# Work Order ID 79738

Item Name: Replacement Skidtube

DRAWING NO. D2580	TITLE 205 SKIDTUBE ASSEMBLY	REV. E	DART AEROSPACE LTD ENGINEERING ORDER		D.E.O. NO. D2580-E-1	SHEET NO. SHEET 1 OF 1	SCALE NTS
DRAWN <i>UP</i>	CHECKED <i>ASS</i>	MFG. APPR. <i>ER</i>	APPROVED <i>#</i>		DE APPR. <i>#</i>		
DATE 11.12.13	DATE 11.12.13	DATE 11.12.13	DATE 11.12.13		DATE 11.12.13

CHANGE ALL C'BORED WELDED CROSSBOLT SPACERS TO SWAGED SPACERS

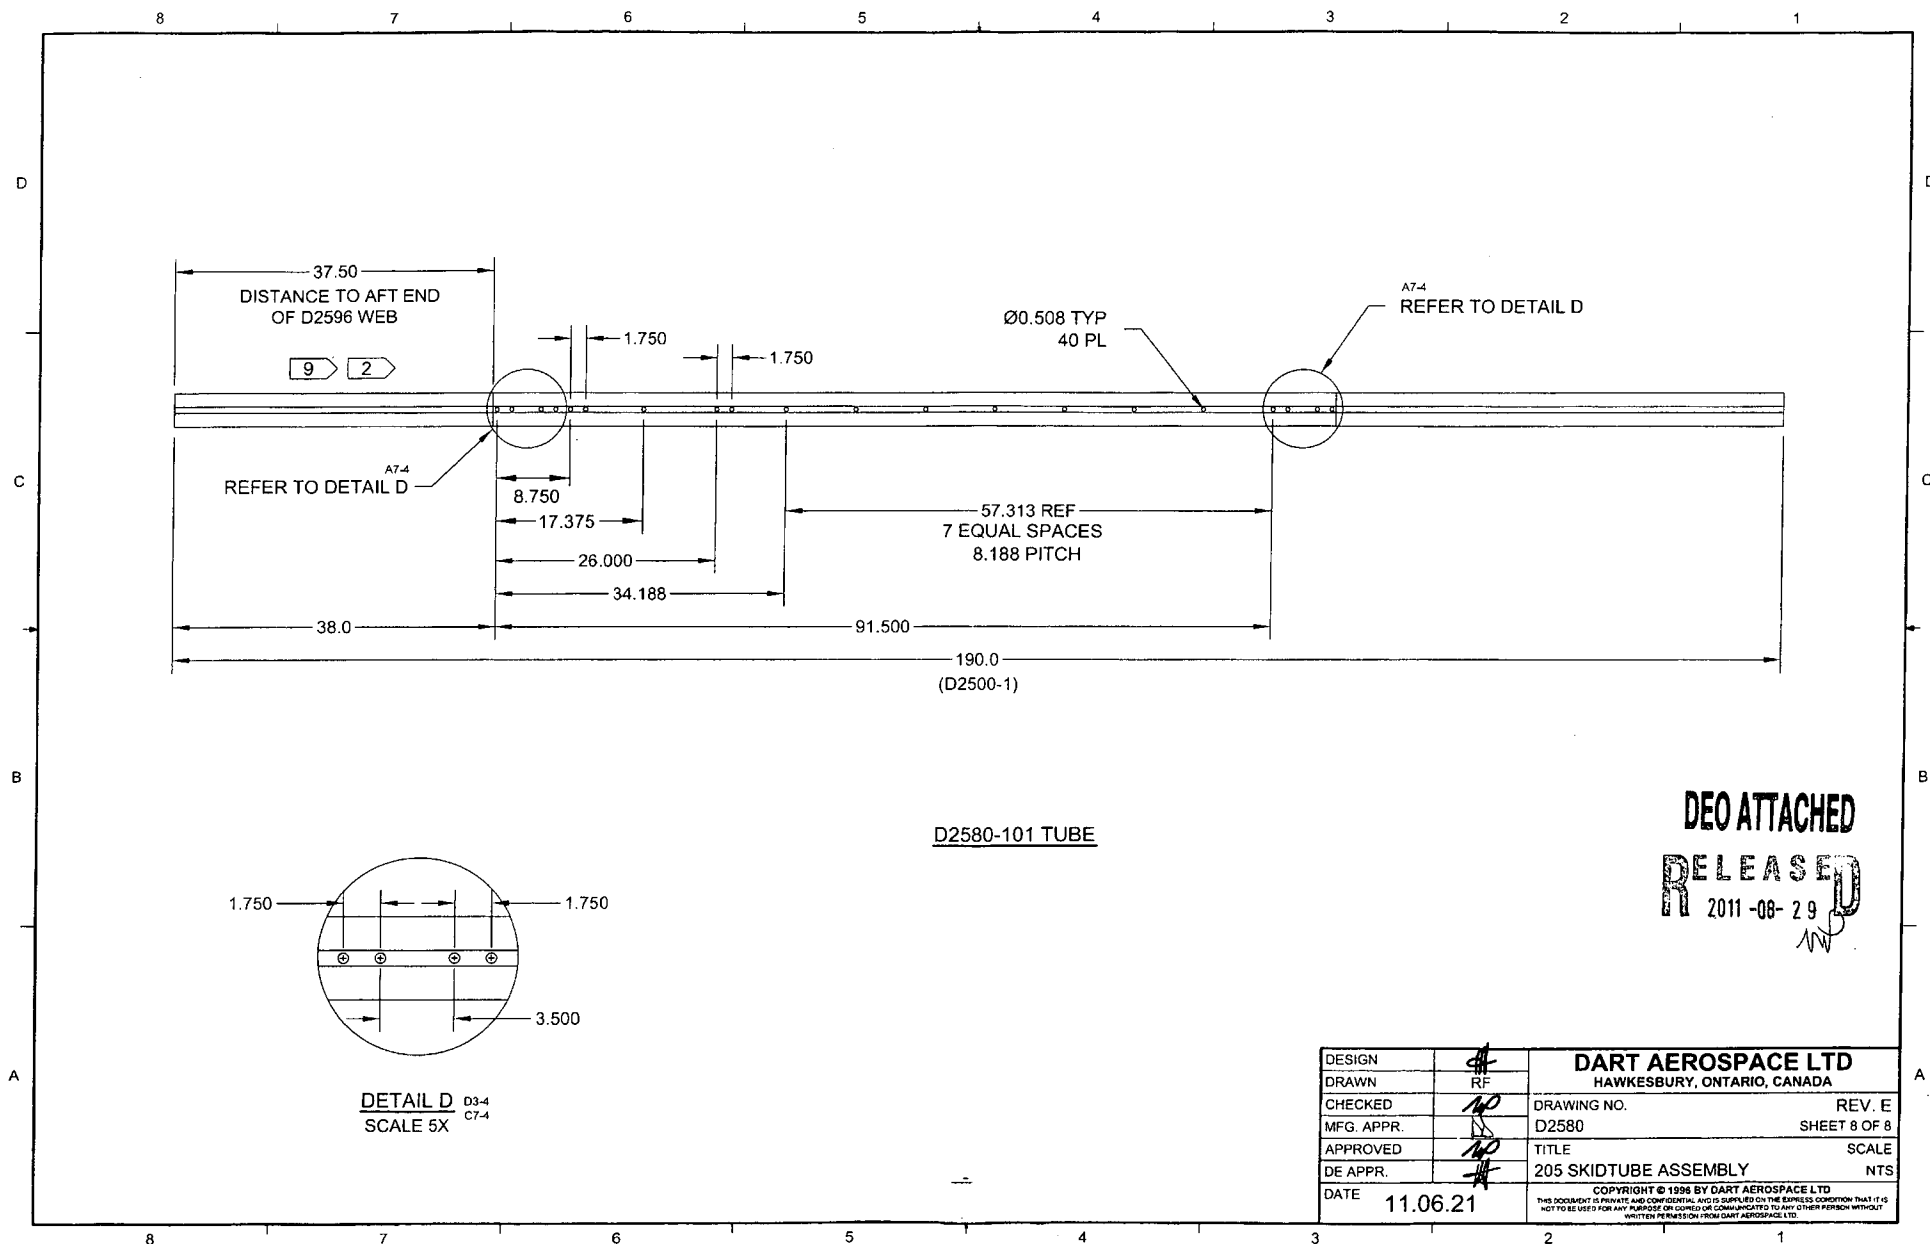
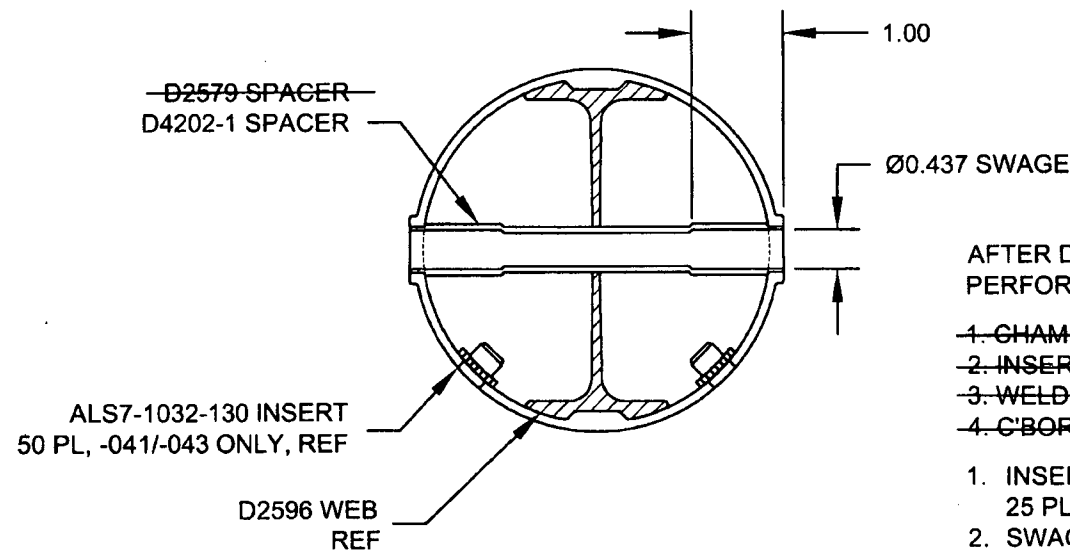
**WAS**

QTY	QTY	QTY	PART NUMBER	DESCRIPTION
-041	-045	-047		
20	24	25	D2579	CROSS BOLT SPACER

**IS**

4		* D2579	CROSS BOLT SPACER
20	20	25	D4202-1	SPACER

\* FOR -045 SKIDTUBE ONLY:  
WELD 4X D2579 SPACERS PER DWG  
IN LOCATIONS MARKED "NO C'BORE".  
REF SHEET 4 OF DWG.
